From: Rikhoff, Jeffrey
Sent: Wednesday, August 11, 2010 3:53 PM
To: Eccleston, Charles
Cc: Imboden, Andy; Pham, Bo
Subject: RE: Salem and Hope Creek Chapter 2 - Technical review of Land Use and Socioeconomics Sections
Attachments: Chapter 2 - V 2 1 (GB DB) - JJR edits 081010.docx

Attached is my redline/strikeout markup, corrections, and comments on Salem HCGS SEIS Chapter 2. I revised and corrected the land use and socioeconomics sections. I also made a few corrections to references to account for new and updated information. Markups of Chapters 4 and 8 to follow.

2.0 AFFECTED ENVIRONMENT

Figure 2-6. Simplified Design of a Pressurized Water Reactor (U.S. Nuclear Regulatory Commission [NRC] 2010a)

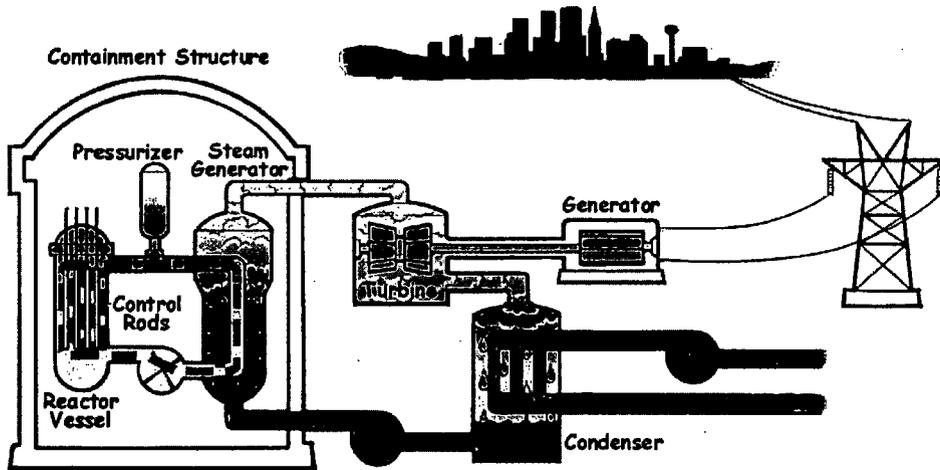
Comment [C2]: We should use an NRC source for this information.

Figure 2-7. Simplified Design of a Boiling Water Reactor (NRC 2010b)

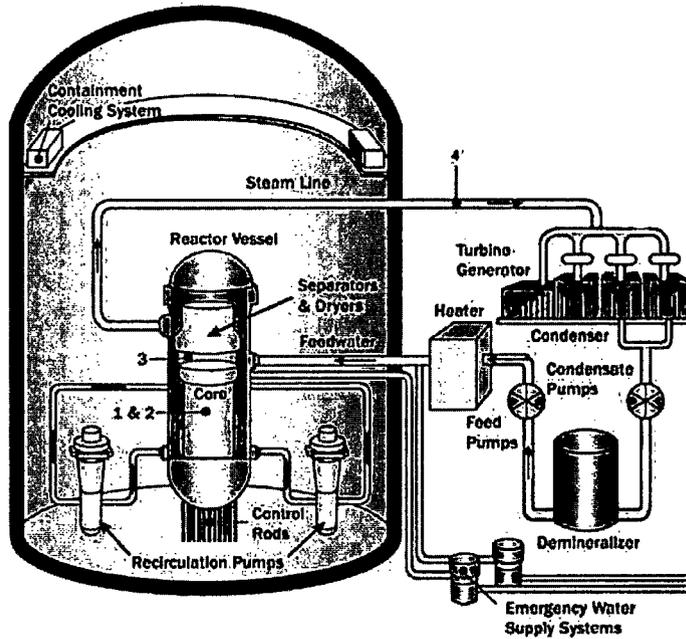
Comment [C4]: See above comment (S1) to use an NRC reference, NUREG-1350
